**SUBJECT: SERVICE BULLETIN S10RY INTERMOTIVE GUARDIAN II
LIFT INTERLOCK WIRING**

MODELS AFFECTED: 2007-2011 MODEL YEAR MICRO BIRD

INTERMOTIVE GUARDIAN II LIFT INTERLOCK POWER SOURCE

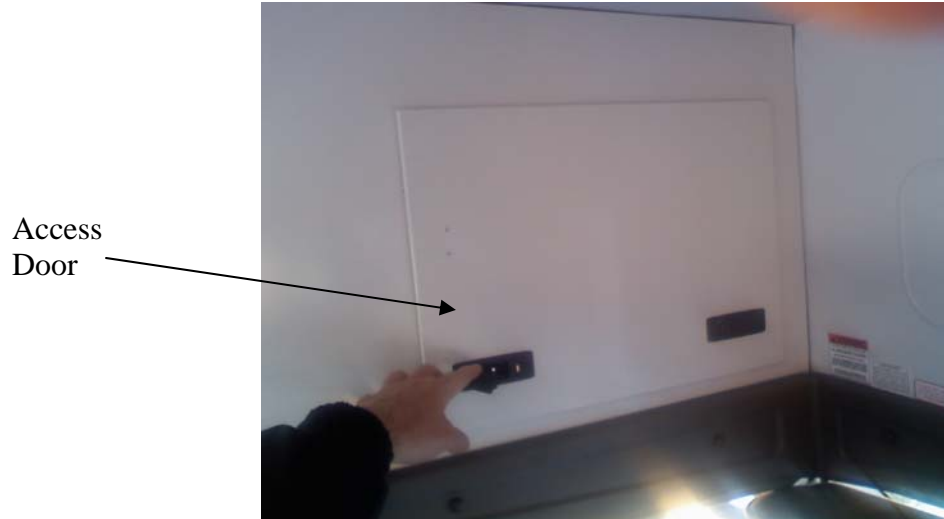
Some buses equipped with the Intermotive Guardian II lift interlock system were incorrectly built with circuit 2502B (Red Wire) connected to ignition power.

Inspect buses equipped with the Intermotive Guardian II lift interlock system. Buses with circuit 2502B (Red Wire) connected to ignition power will be rewired to battery power.

Remove Screws

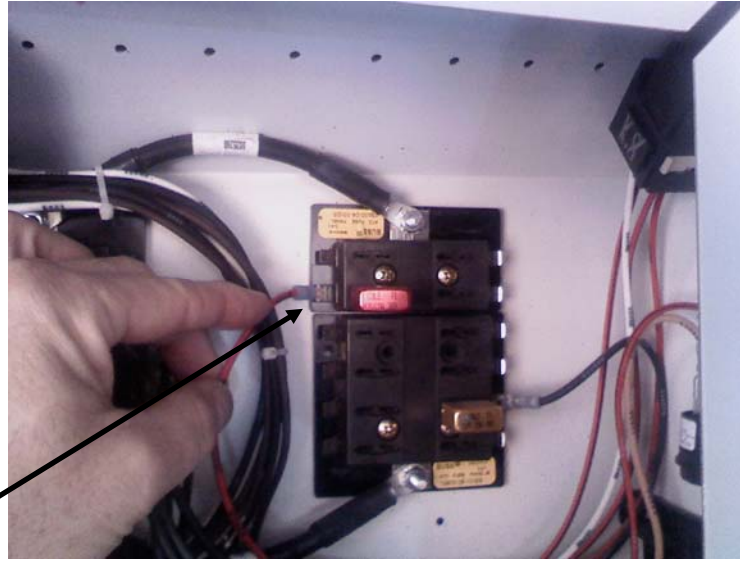
3. Remove four screws that attach cover at rear of driver compartment. (See above photo)
